SUNDANCE WEST SUBDIVISION
EL PASO COUNTY, COLORADO
Grading & Erosion Control Plans

EPC STORMWATER REVIEW COMMENTS IN ORANGE BOXES WITH BLACK TEXT

PCD FILE NO. SF-2527

TYPICAL RIPRAP APRON/ CULVERT OUTLET PAVING (1)
N.T.S.

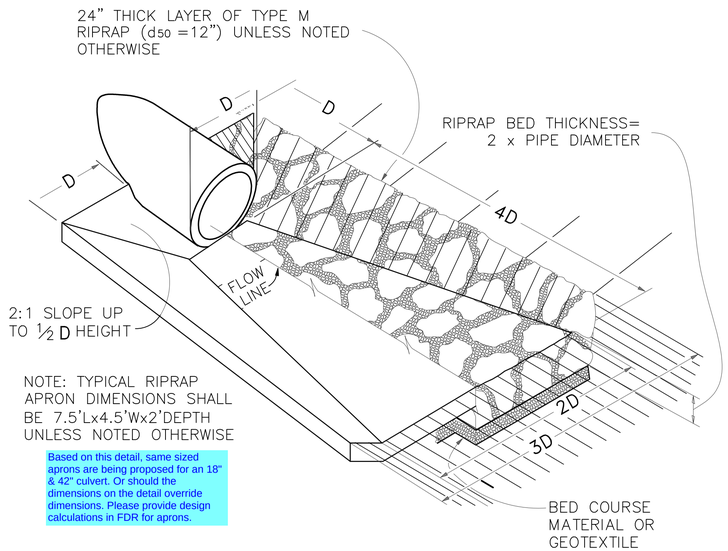
Based on this detail, same sized aprons are being proposed for an 18" & 42" culvert. Or should the dimensions on the detail override dimensions. Please provide design calculations in FDR for aprons.

GRADING AND EROSION CONTROL PLAN

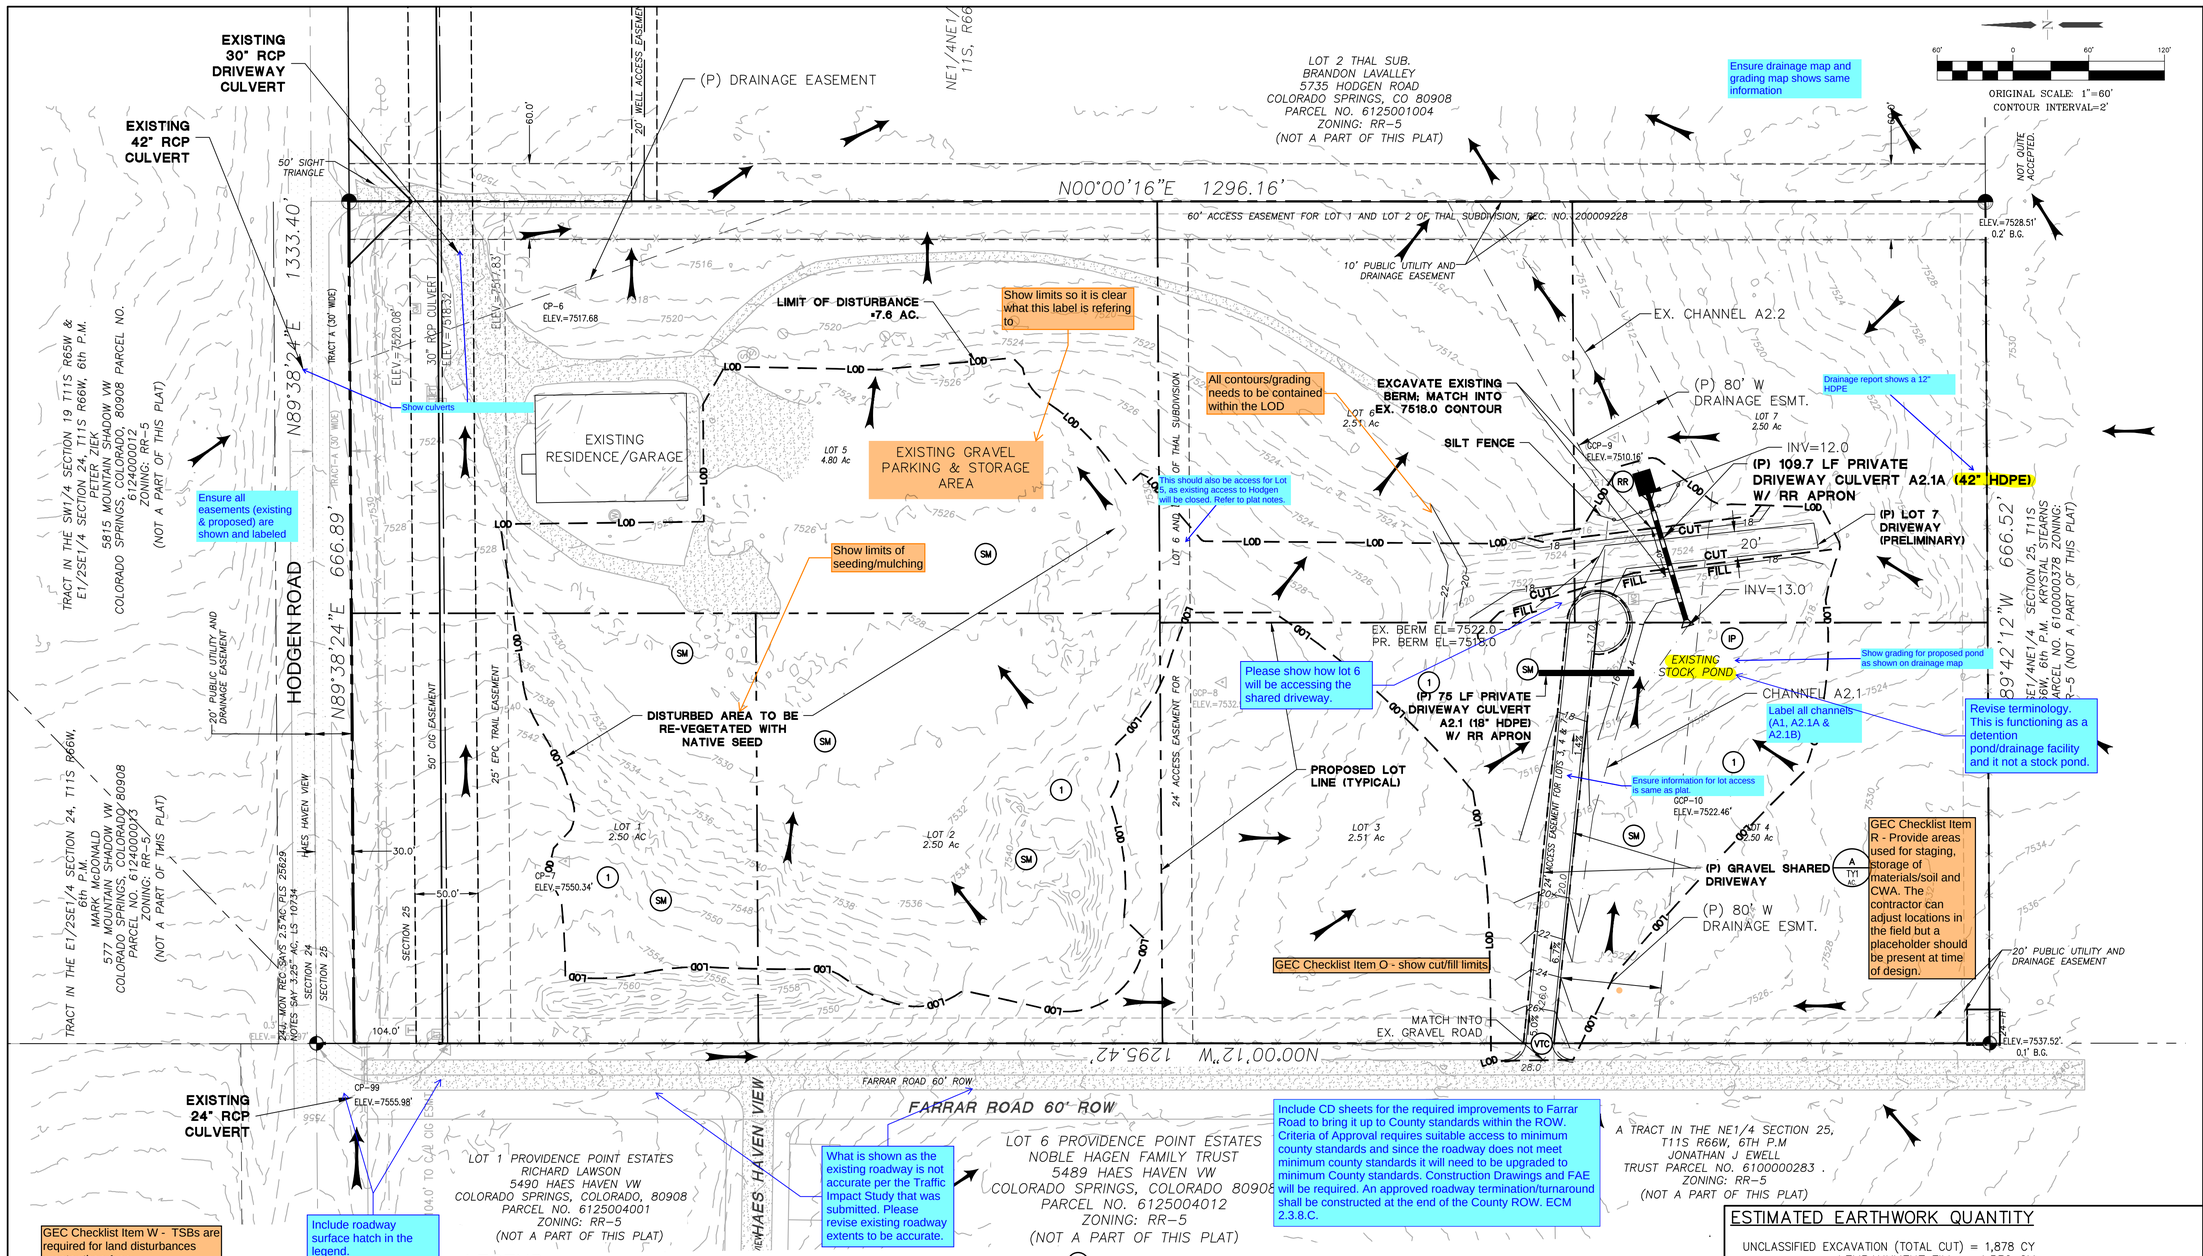
Add a general note: all areas to be vegetated with seeding should also be temporarily stabilized via surface roughening or some other means. Show surface roughening limits on GEC Plan.

Show culverts

Show grading for proposed pond as shown on drainage map

What is shown as the existing roadway is not accurate per the Traffic Impact Study that was submitted. Please revise existing roadway extents to be accurate.

Revise terminology. This is functioning as a detention pond/drainage facility and it not a stock pond.

Please show how lot 6 will be accessing the shared driveway.

Show limits of seeding/mulching

GEC Checklist Item R - Provide areas used for staging, storage of materials/soil and CWA. The contractor can adjust locations in the field but a placeholder should be present at time of design.

GEC Checklist Item O - show cut/fill limits

Show limits so it is clear what this label is refering to

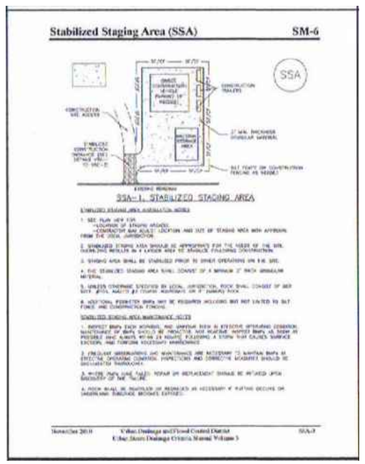
Provide details for: TSB
